Model: Perfect Binder GB5000	Date: 20-June -08	No.: RD391001a
-------------------------------------	-------------------	----------------

Subject: Firmware Release Note: P-Binder_B1		Prepared by: T.Tadokoro	
From: PPBG QA/Service Planning Dept.			
Classification:	<input type="checkbox"/> Troubleshooting	<input type="checkbox"/> Part information	<input type="checkbox"/> Action required
	<input type="checkbox"/> Mechanical	<input type="checkbox"/> Electrical	<input type="checkbox"/> Service manual revision
	<input type="checkbox"/> Paper path	<input type="checkbox"/> Transmit/receive	<input type="checkbox"/> Retrofit information
	<input checked="" type="checkbox"/> Other ()

Subject: STAY: Parts catalog correction		Prepared by: T. Tadokoro	
From: PPBG QA/Service Planning Dept.			
Classification:	<input type="checkbox"/> Troubleshooting <input type="checkbox"/> Mechanical <input type="checkbox"/> Paper path <input type="checkbox"/> Other ()	<input checked="" type="checkbox"/> Part information <input type="checkbox"/> Electrical <input type="checkbox"/> Transmit/receive	<input type="checkbox"/> Action required <input type="checkbox"/> Service manual revision <input type="checkbox"/> Re

20.Vertical Feed Section 1 (D391)

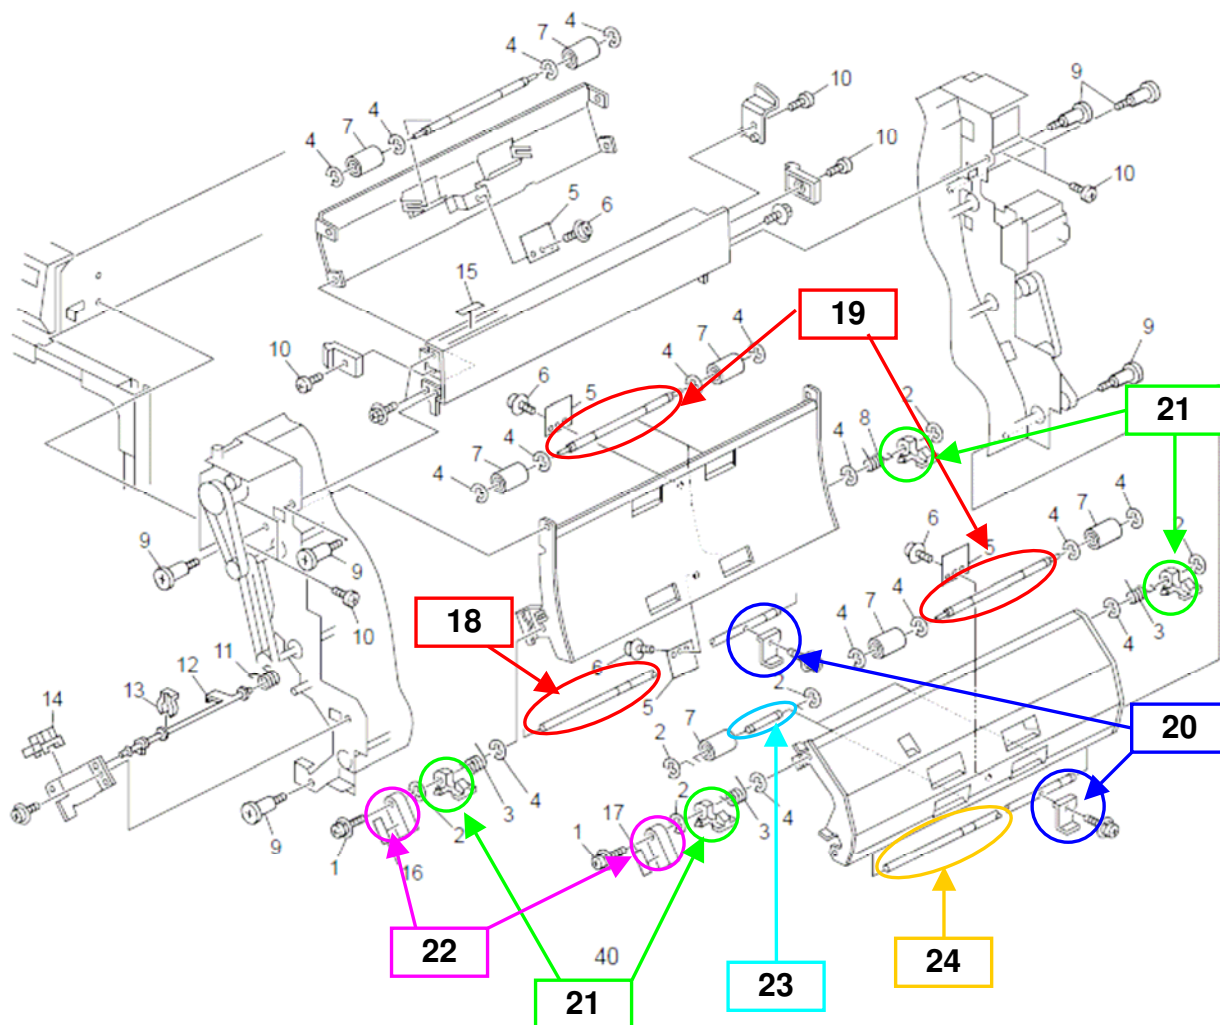
Part Number	Description	Q'ty	Int	Page	Index	Note
D3911520	SHAFT: LOCK: PF3091P845	1	-	40	18	Add
D3911521	SHAFT: TFD: PF3091P847	2	-	40	19	Add
D3911522	BRACKET: POSITIONING: SENSOR: PF3091P141	2	-	40	20	Add
D3911523	ARM: LOCK: PF4140P120	4	-	40	21	Add
D3911525	HANDLE: ARM: LOCK: PF4155P607	2	-	40	22	Add
D3911526	SHAFT: TFD: PF3091P846	1	-	40	23	Add
D3911527	SHAFT: LOCK: GUIDE: PF3091P843	1	-	40	24	Add

62.Cover Feed Path Section 6 (D391)

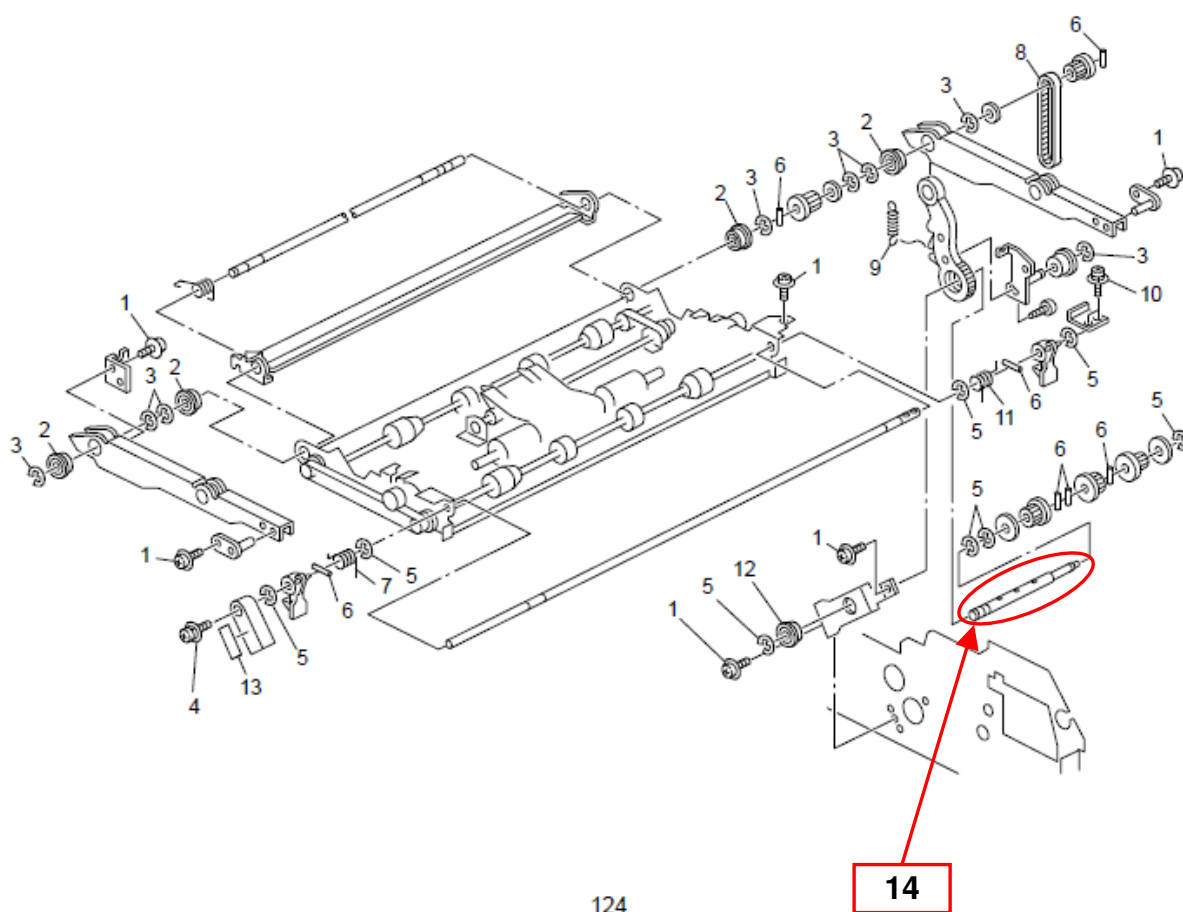
Part Number	Description	Q'ty	Int	Page	Index	Note
D3911515	SHAFT: IDLER: TRANSPORT SUB-UNIT: PF4155P761	1	-	124	14	Add

65.Cover Feed Path Section 9 (D391)

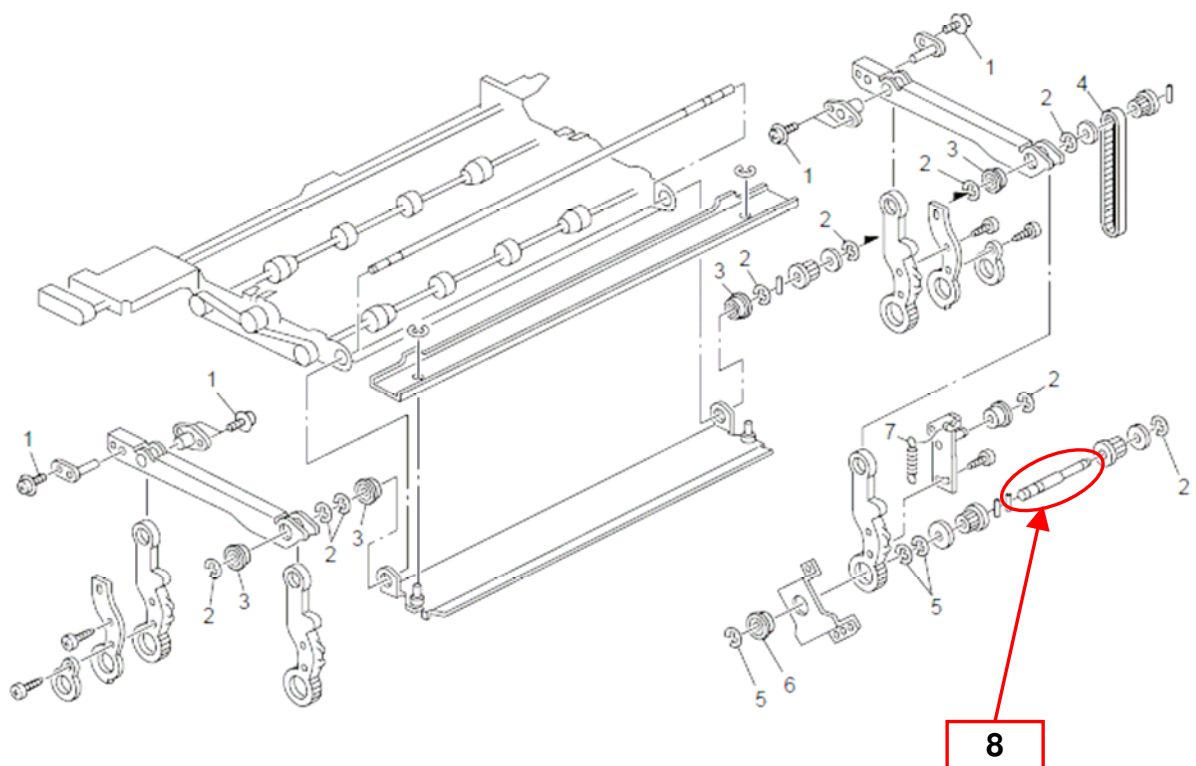
Part Number	Description	Q'ty	Int	Page	Index	Note
D3911514	SHAFT: CONTACT POINT: TRANSPORT SUB-UNIT: PF4155P695	1	-	130	8	Add

73.Bundle Feed Section 2 (D391)

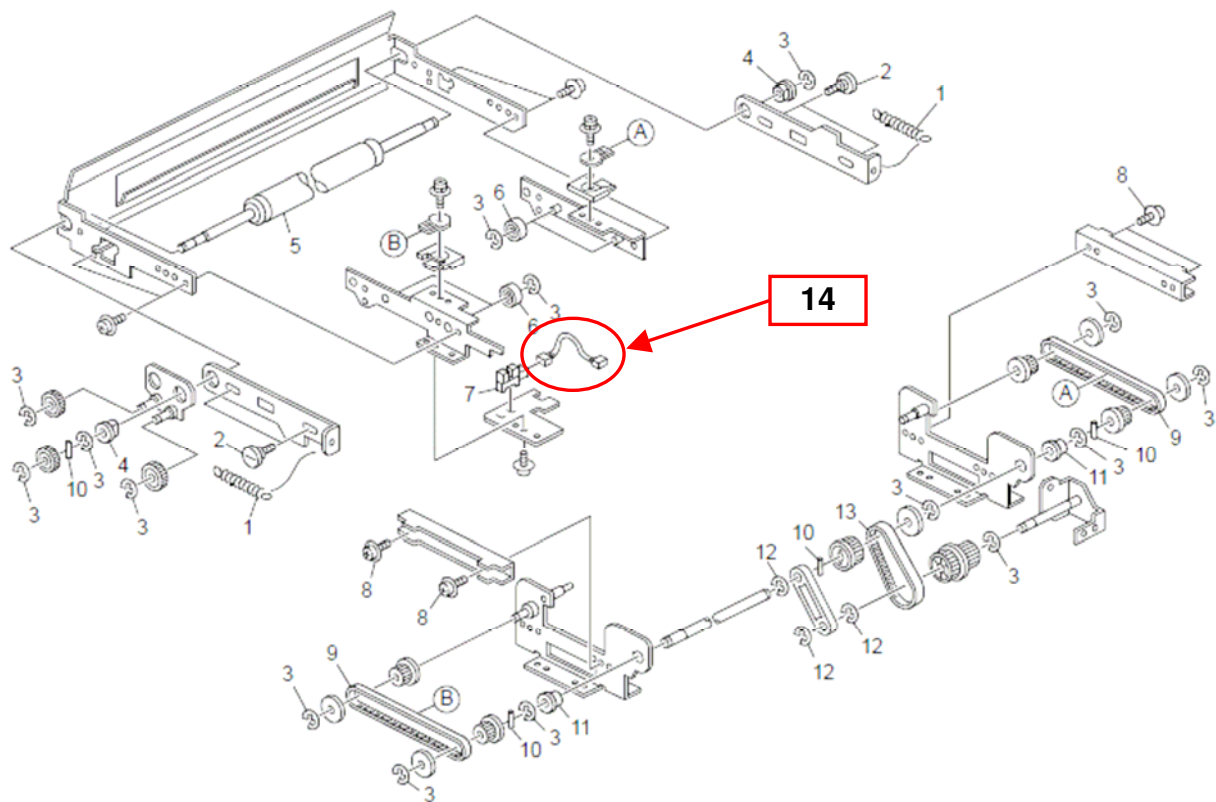
Part Number	Description	Q'ty	Int	Page	Index	Note
D3915314	HARNESS: PAPER FEED SENSOR: PF4140K782	1	-	146	14	Add

77.Stack Rotation Section 2 (D391)

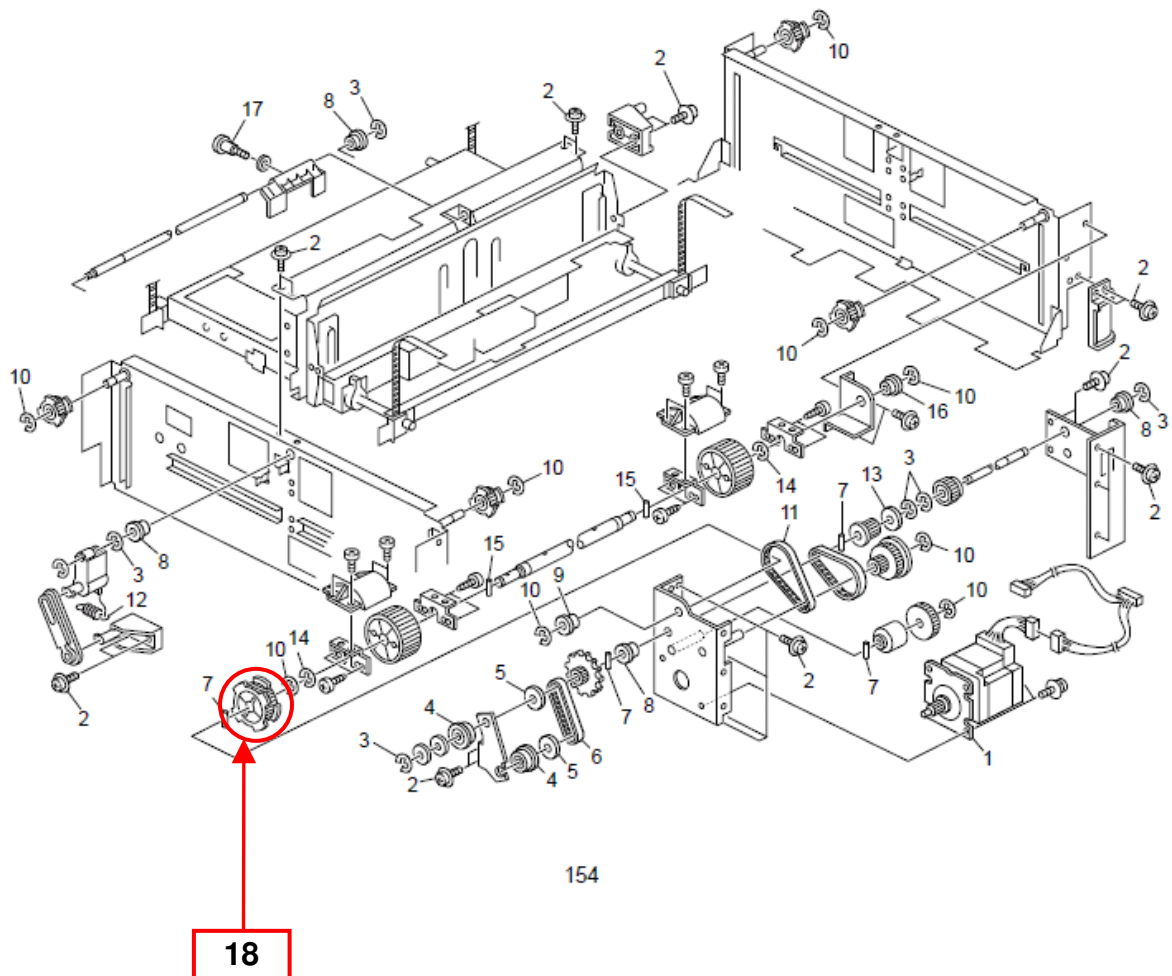
Part Number	Description	Q'ty	Int	Page	Index	Note
D3911511	TIMING PULLEY: PF4140Q753A1	1	-	154	18	Add

93.Electrical Section 2 (D391)

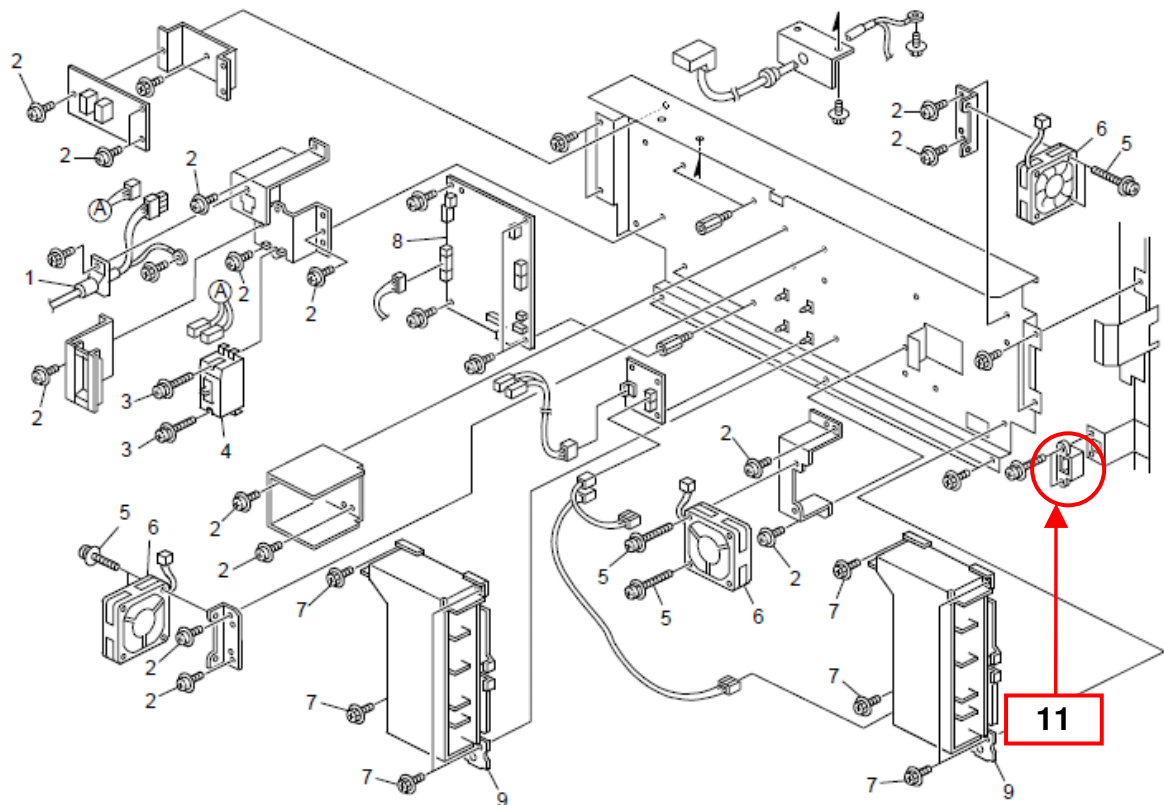
Part Number	Description	Q'ty	Int	Page	Index	Note
D3915312	HARNESS: CONNECTING: PF4155K908	1	-	186	11	Add

39.Sub Gripper Section 2 (D391)

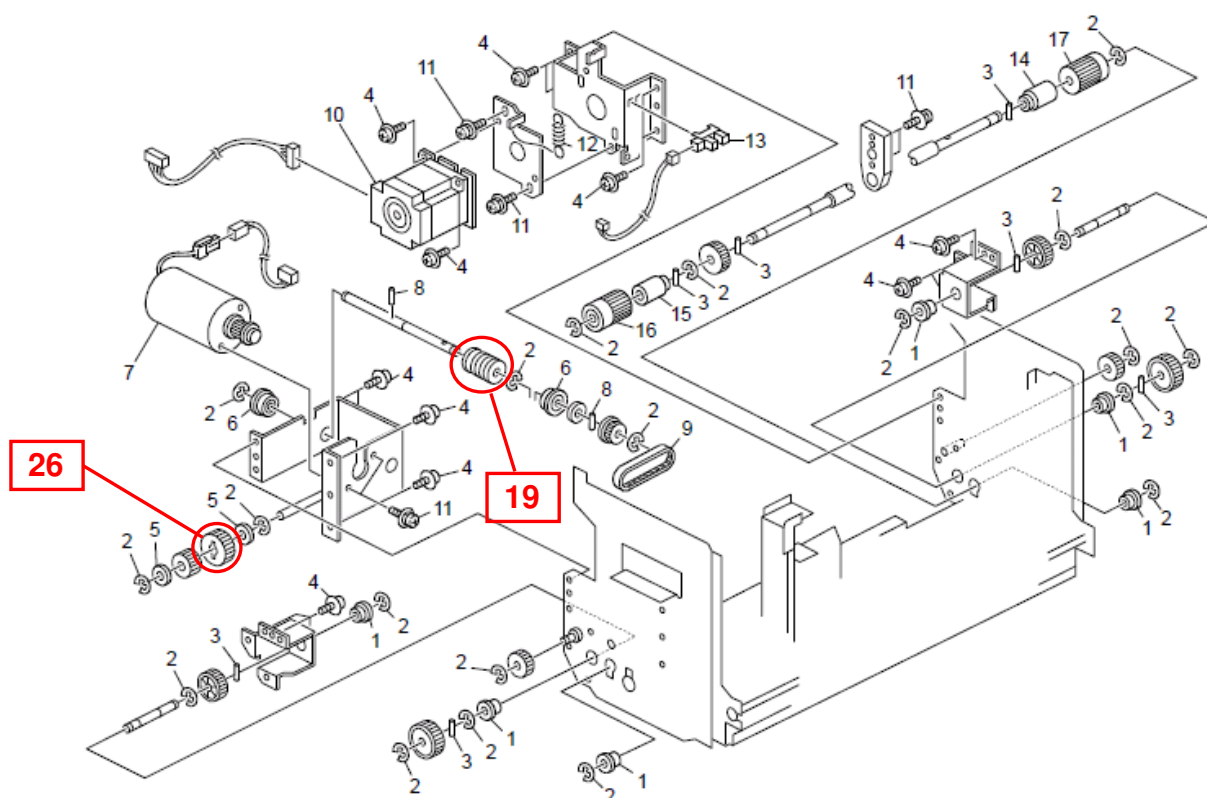
Old Part Number	New Part Number	Description	Q'ty	Int	Page	Index
D3911490	D3911507	GEAR:WORM GEAR:PF4140P484	1	-	79	19
D3911495	D3911506	GEAR:PF4140P394		-	79	26

4.Transit Pass Unit 1 (D391)

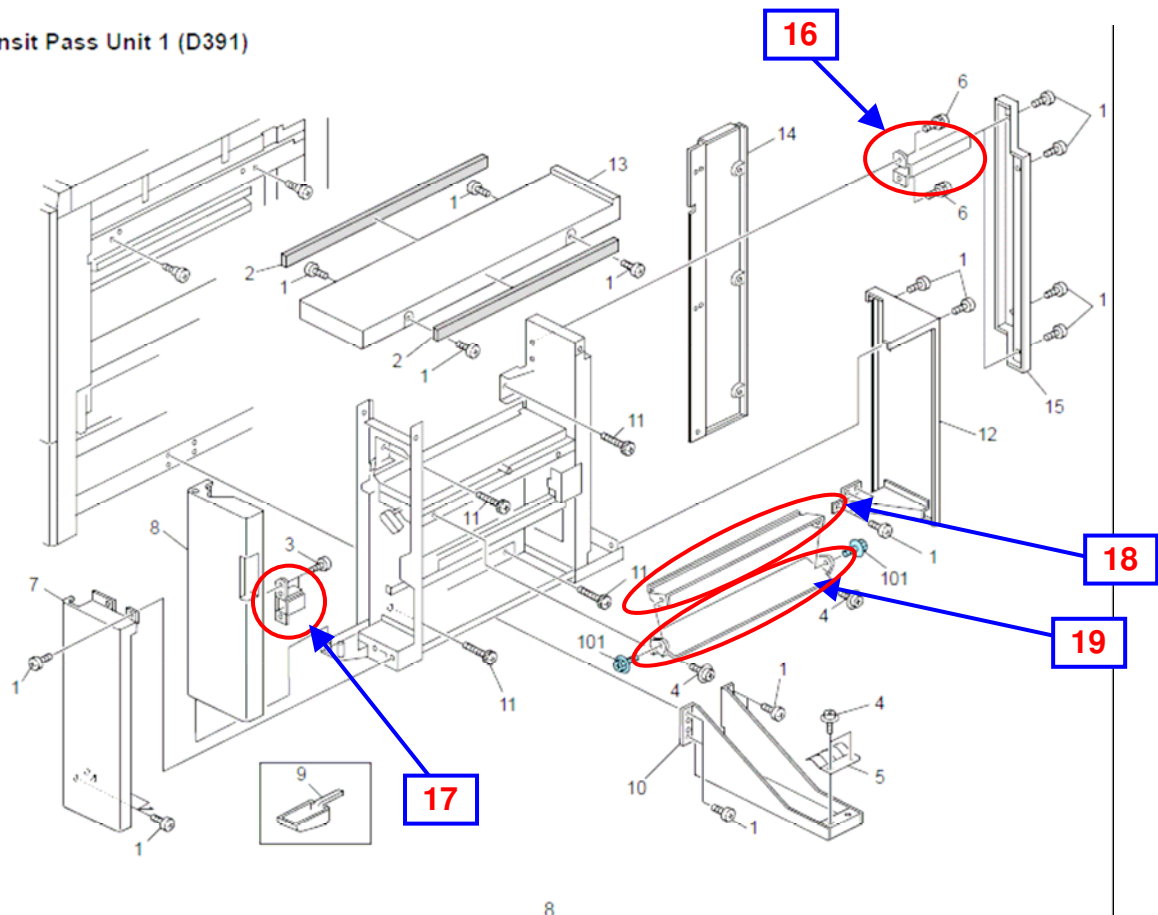
New Part Number	Description	Q'ty	Int	Page	Index	Note
D3914513	Bracket:Cover:Rear:PF4165Q625	1	-	8	16	Add
D3914514	Bracket:Magnet Catch:PF4165Q626	1	-	8	17	Add
B6601768	Guide Plate:Connecting:PF4147P818A	1	-	8	18	Add
B8307511	Guide Plate:Connecting:Lower	1	-	8	19	Add

5.Transit Pass Unit 2 (D391)

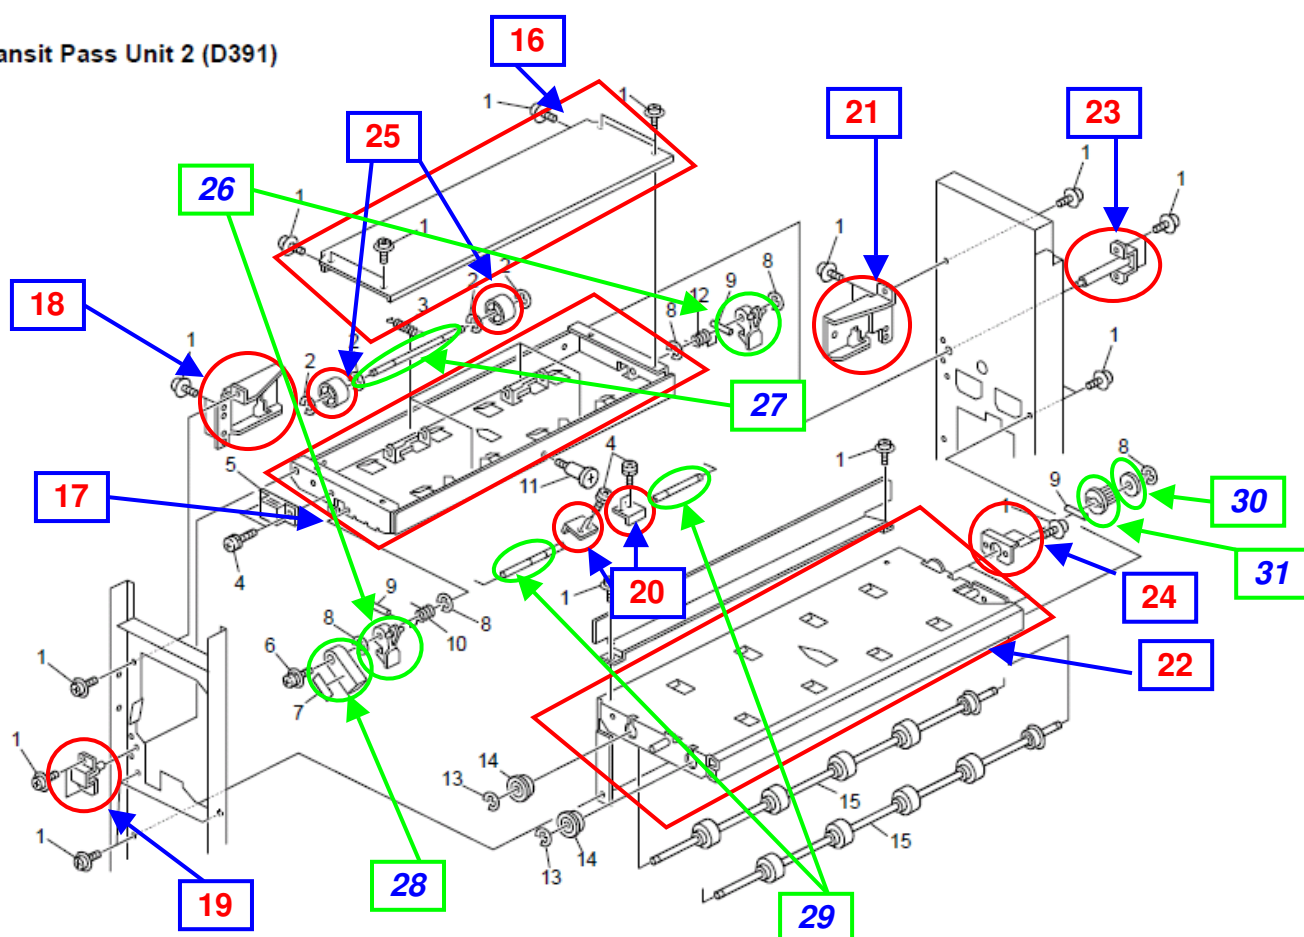
New Part Number	Description	Q'ty	Int	Page	Index	Note
D3914515	Cover:Upper:PF4165Q618	1	-	10	16	Add
D3914516	Stay:Transport:Upper:PF4165Q604	1	-	10	17	Add
D3914517	Bracket:Transport:Front:PF4165Q607	1	-	10	18	Add
D3914526	Shaft:Transport Sub-Unit: Front: PF4165K604	1	-	10	19	Add
D3914529	Plate:Release:PF4140P637	2	-	10	20	Add
D3914531	Bracket:Transport:Rear:PF4165Q608	1	-	10	21	Add
D3914532	Stay:Transport:Lower:PF4165Q606	1	-	10	22	Add
D3914533	Shaft:Transport Sub-Unit: Rear:PF4165K605	1	-	10	23	Add
D3914536	Bracket:Shaft:Transport Roller: PF4165Q609	1	-	10	24	Add
D3911350	Collar:PF4140P958A	2	-	10	25	Add
D3914528	BRACKET:RELEASE:PF4140P120	2	-	10	26	Add
D3914518	SHAFT:ROLLER:PF4140P618	1	-	10	27	Add
D3914519	HOLDER:SHAFT:RELEASE:PF4155P607	2	-	10	28	Add
D3914530	SHAFT:RELEASE:PF4165Q651	1	-	10	29	Add
D3914535	FLANGE:TIMING PULLEY:PF4099P225	1	-	10	30	Add
D3914534	TIMING PULLEY:S2MX16:PF4140P631	1	-	10	31	Add
